Please find attached the Response to Information Request for Development Application MCU26/0019 – Function Facility at 235–353 Mill Road, Yabulu.

Subject: MCU26/0019-Letter - Information Request - 235-353 Mill Road YABULU

**Re: Response to Information Request – Application MCU26/0019
Development Permit for Material Change of Use – Function Facility**

PROJECT : VENUE
ADDRESS : LDT3 RP743037
235-353 MILL ROAD. YABULU QLD 4818
DRAWING NO. GA001 REV.0

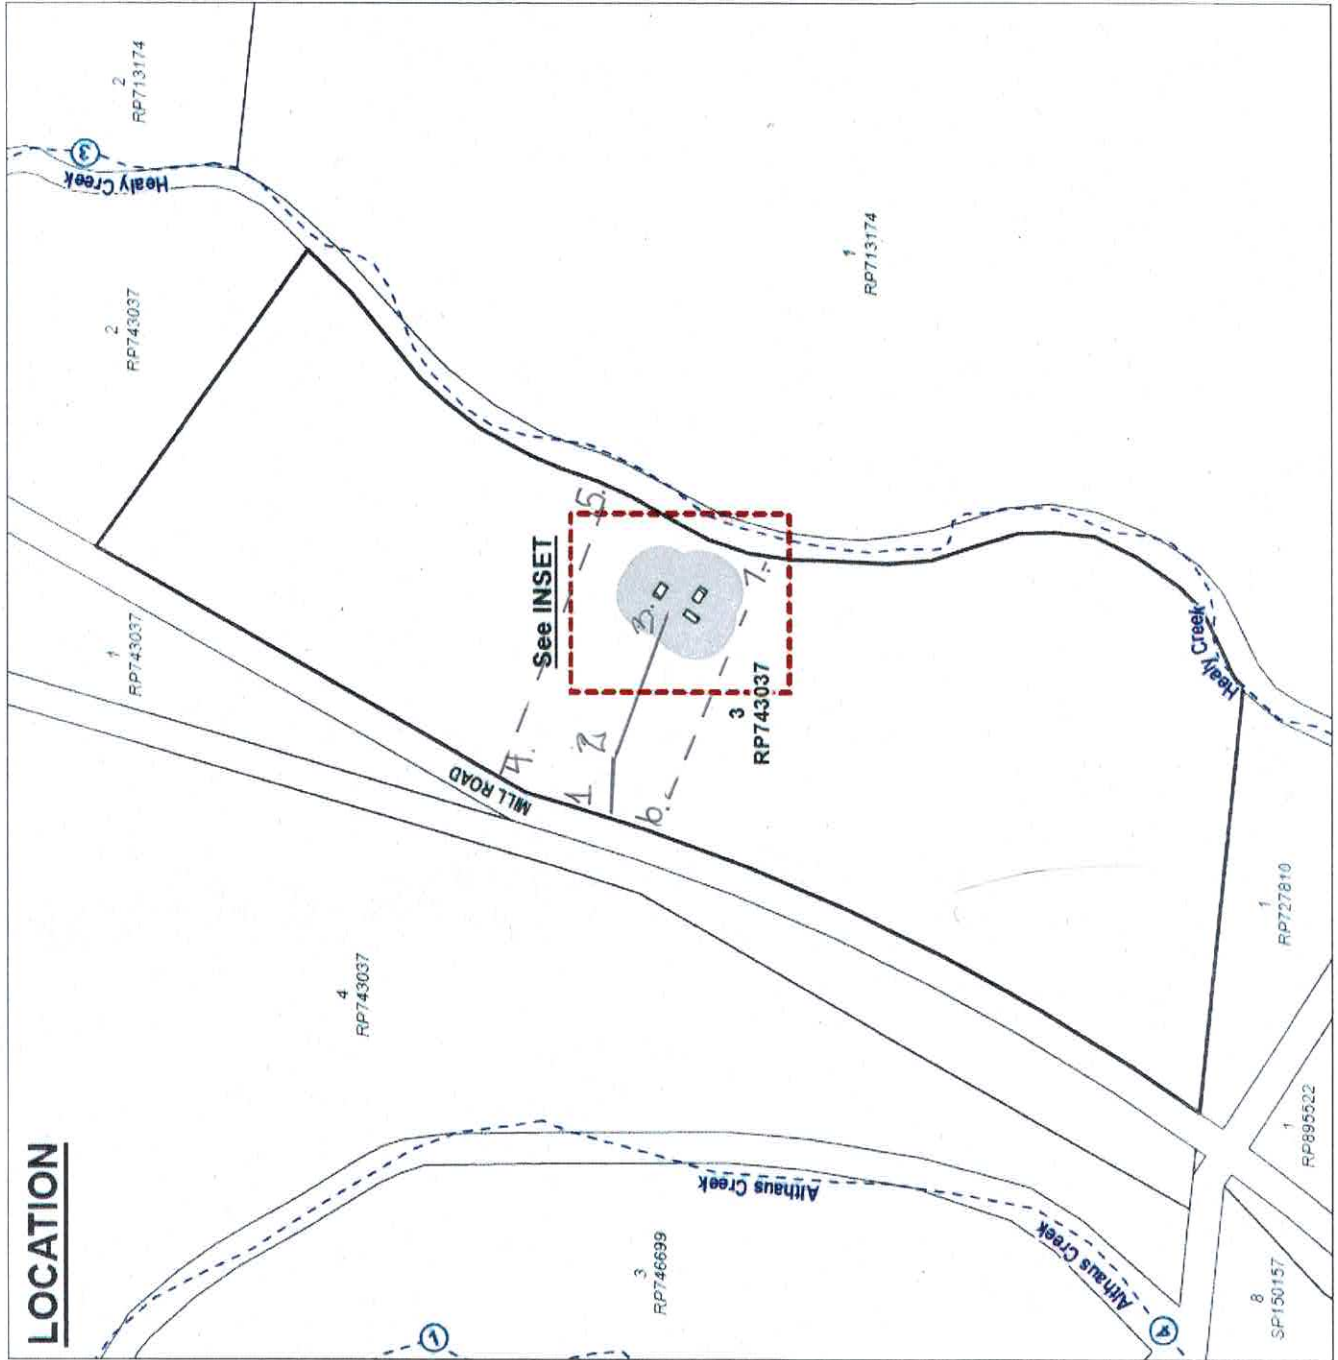
- **Site plan**, including
 - Site boundaries
 - Existing and proposed buildings, structures, fences and infrastructure (including potable water and fire management water storage tanks, refuse storage and collection and onsite sewer) with dimensions
 - Footprint of use area, including fire breaks and vegetation buffers,
 - Dimensions of setbacks to boundaries,
 - Existing and proposed driveway, internal circulation, parking areas and bus drop off location capable of accommodating expected demand, (relocate the car parking area to the other side of the access road, away from vegetation supporting native fauna);
 - North point,
 - Title block (e.g., title, date, version, and reference number)
- **Elevations**, including
 - Existing and proposed buildings, and structures,
 - height from natural ground level
 - title block (e.g., title, date, version, and reference number).

- Site boundaries – Refer to Drawing GA001 Rev.0 – Site Access & Boundary. The venue footprint is consistent with the approved Vegetation Management Plan (DWG No. VMP 2603-5187 SRA). A boundary fence is proposed around the approved venue area to restrict public access to the remainder of
